# Access Compliance Report

## Public Rights-of-Way

### (Curb Ramps)

Intersection ID: 49291	Main Street: ARDREY_CREST_DR	Cross Street: CHAMBERLIN_RD	Location: NE
ADA ID: 8D8FD636298E	Ramp Type: PerpDiag	Initial Pass/Fail: Fail	Overall Compliance: No
Codes/Mitigation Info/Possible Solution		Field Measurements/Component Compliance

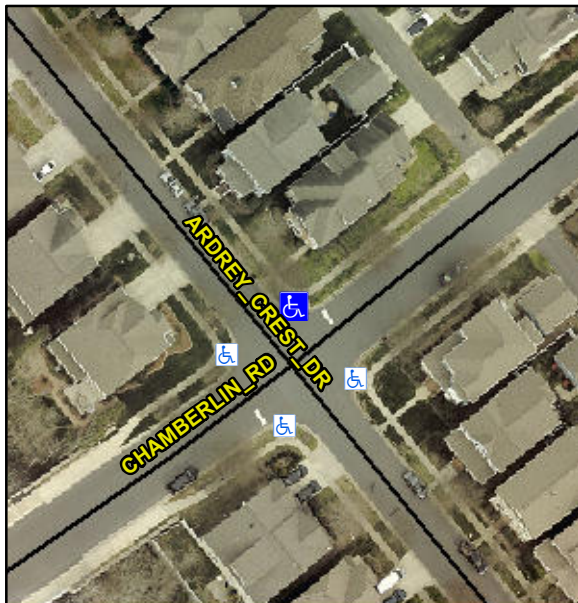
**Not Found, R304.5.1, R304.2.2**

Compliance	Description	Data	Compliance	Description	Data
N/A	Ramp Length (in)	72.0	No	Ramp Slope (%)	8.8
No	Ramp Width (in)	46.0	Yes	Ramp XSlope (%)	0.9
N/A	Flare Type LT	N/A	N/A	Flare Type RT	N/A
N/A	Flare Slope LT (%)	N/A	N/A	Flare Slope RT (%)	N/A
N/A	Flare Traversable LT?	N/A	N/A	Flare Traversable RT?	N/A
N/A	Landing Length (in)	N/A	N/A	DWS Provided?	N/A
N/A	Landing Width (in)	N/A	N/A	DWS Contrast?	N/A
N/A	Landing Slope (%)	N/A	N/A	DWS Length (in)	N/A
N/A	Landing X Slope (%)	N/A	N/A	DWS Full Width?	N/A
N/A	Landing Curb? (Y/N)	N/A	N/A	DWS Offset (in)	N/A
N/A	Shared Landing?	N/A			
N/A	Gutter Ponding?	N/A	N/A	Gutter Slope (%)	N/A
N/A	Gutter Lip Ht (in)	N/A	N/A	Gutter X Slope (%)	N/A
N/A	Painted X Walk1?	No	N/A	Painted X Walk2?	No
	X Walk 1 Direction	To SW		X Walk 2 Direction	To SE
N/A	X Walk 1 Width (in)	N/A	N/A	X Walk 2 Width (in)	N/A
	X Walk 1 Slope (%)	4.4		X Walk 2 Slope (%)	2.6
	X Walk 1 X Slope (%)	0.1		X Walk 2 X Slope (%)	3.1

**Remove & Replace Curb Ramp With Two New Directional Ramps or Equivalent.**
